HUDSON LOGISTICS CENTER

SP #12-22 & CU #07-22

December 14, 2022

Staff Report #3

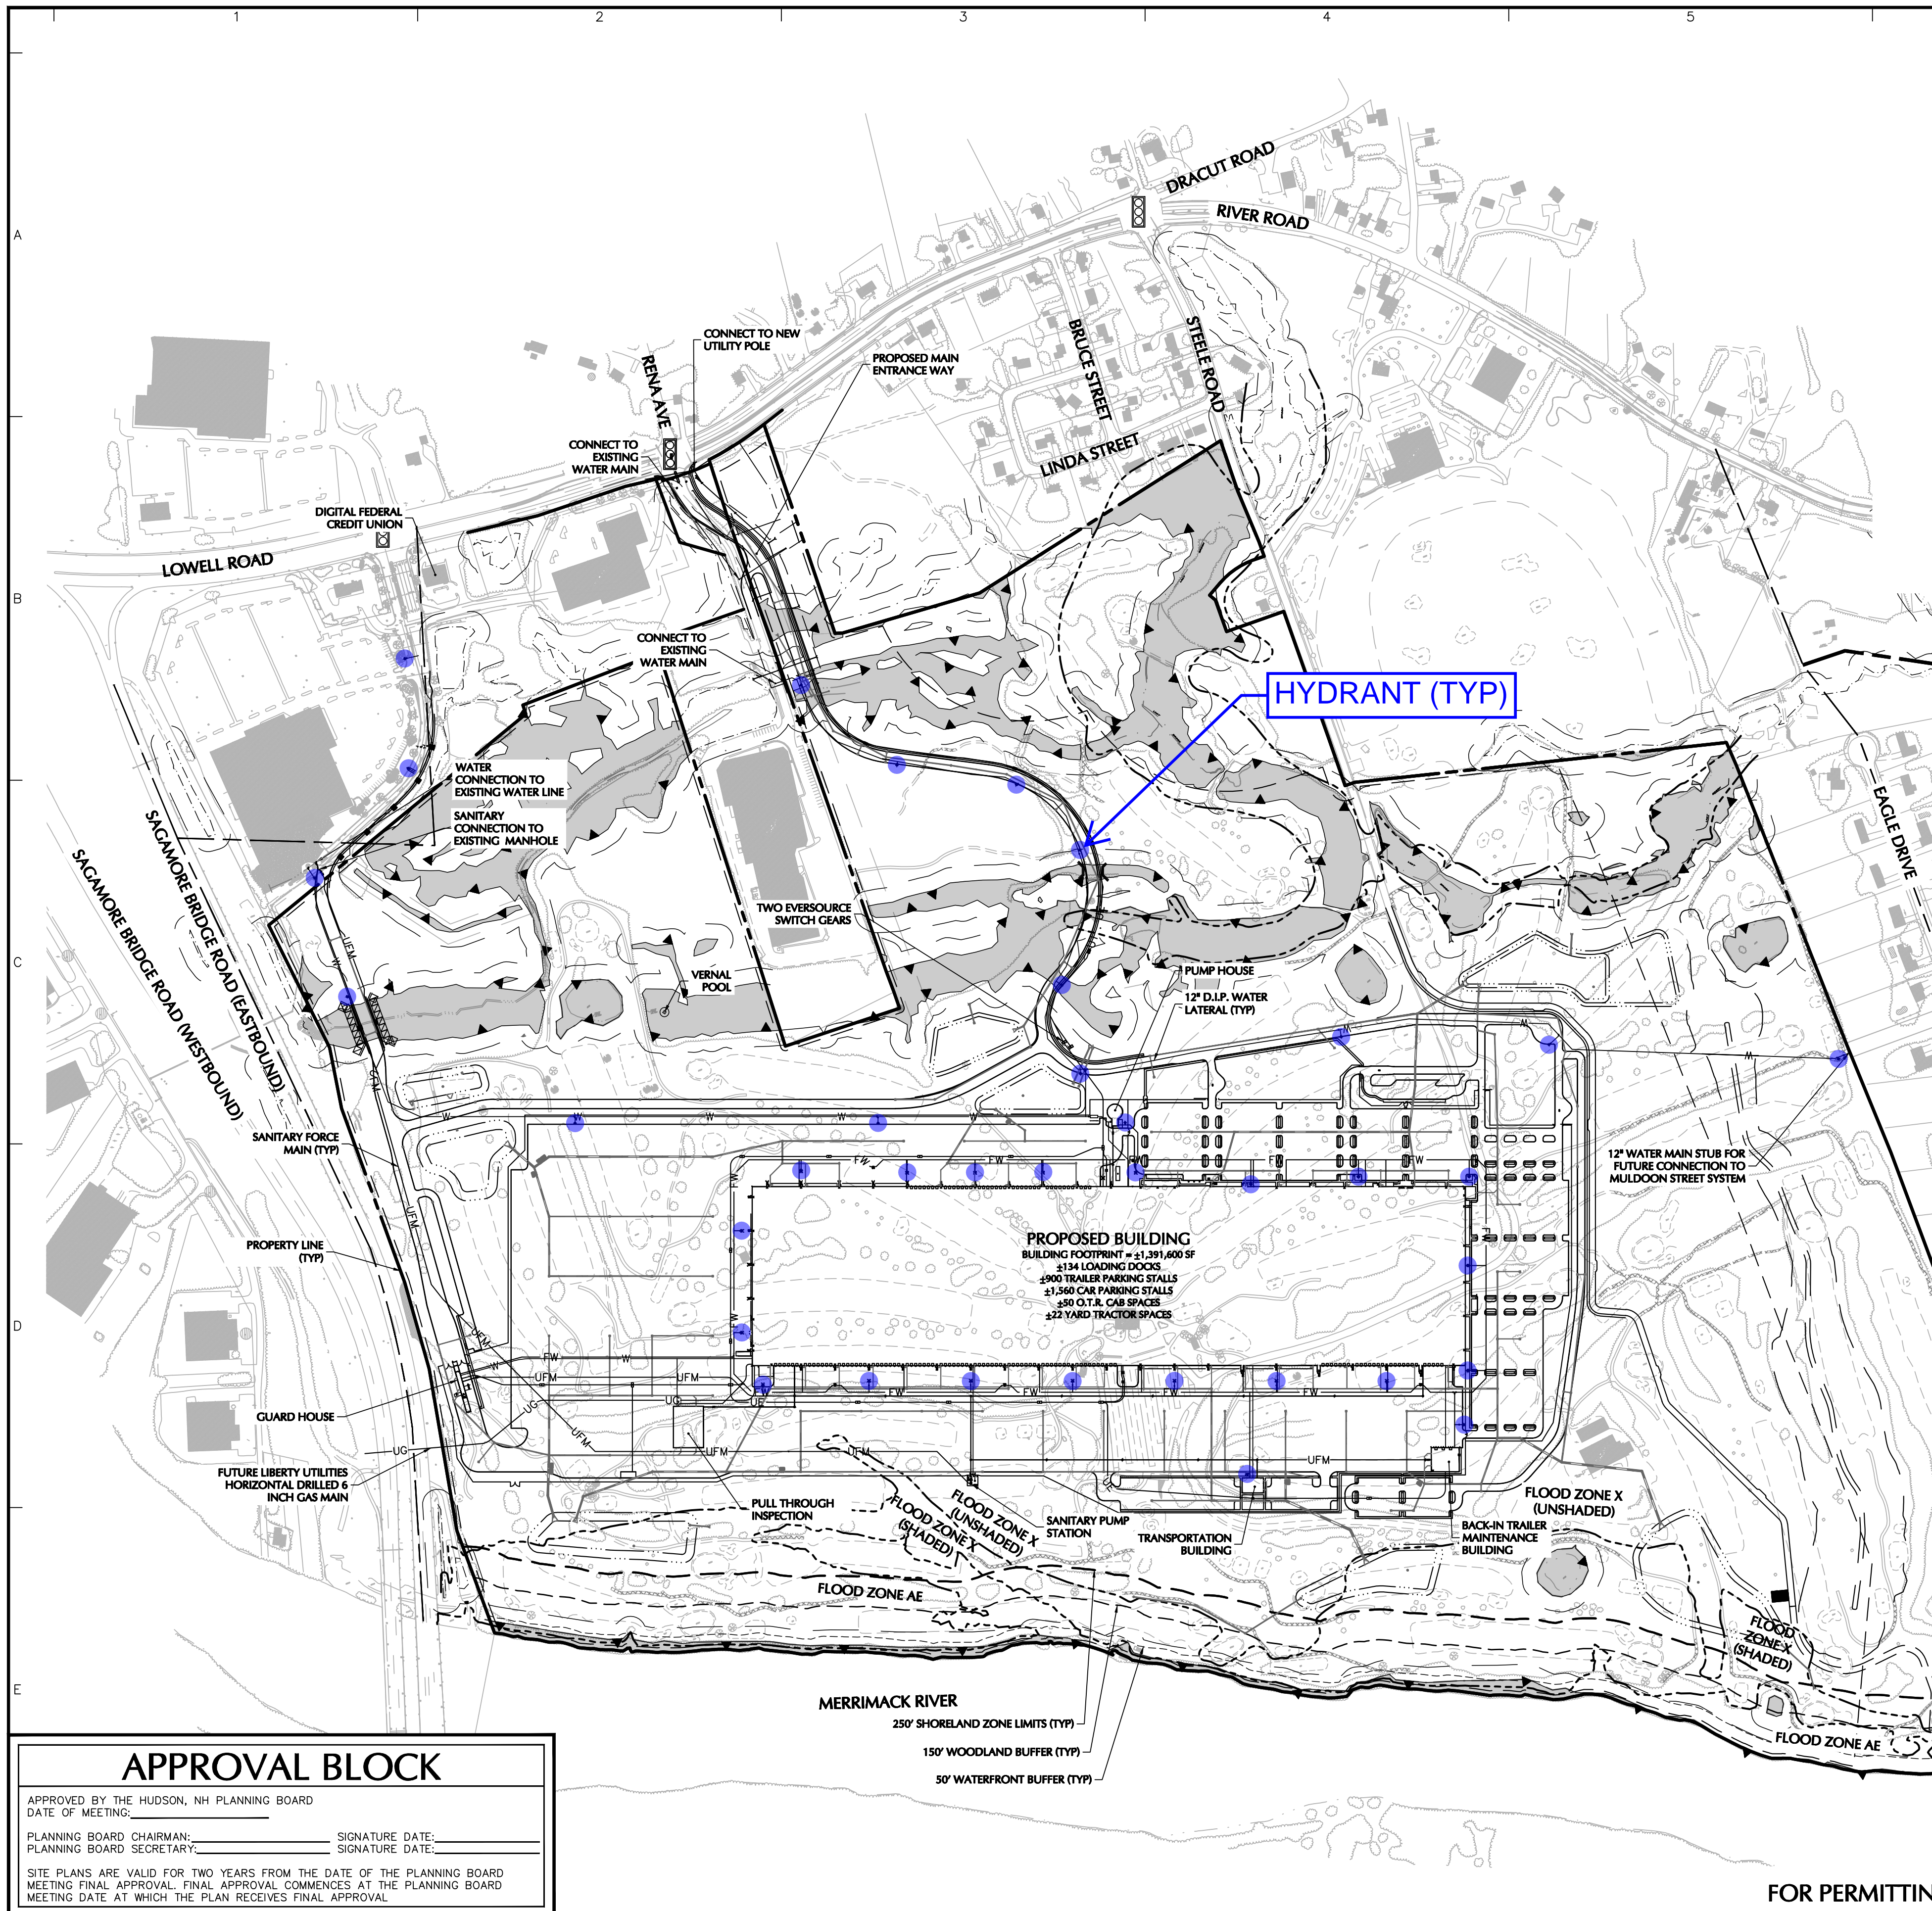
- C. There is an associated risk with the amount of equipment on the roof of the building. This equipment will lead to the roof being a common response area for the Hudson Fire Department. In an effort to safety and efficiently work in this area, we will need to review the need of a tower truck for the Hudson Fire Department fleet. This need is created by the sheer size of the building as a facility of this size is not currently part of our risk assessment.

COMMENT RESPONSE: Acknowledged.
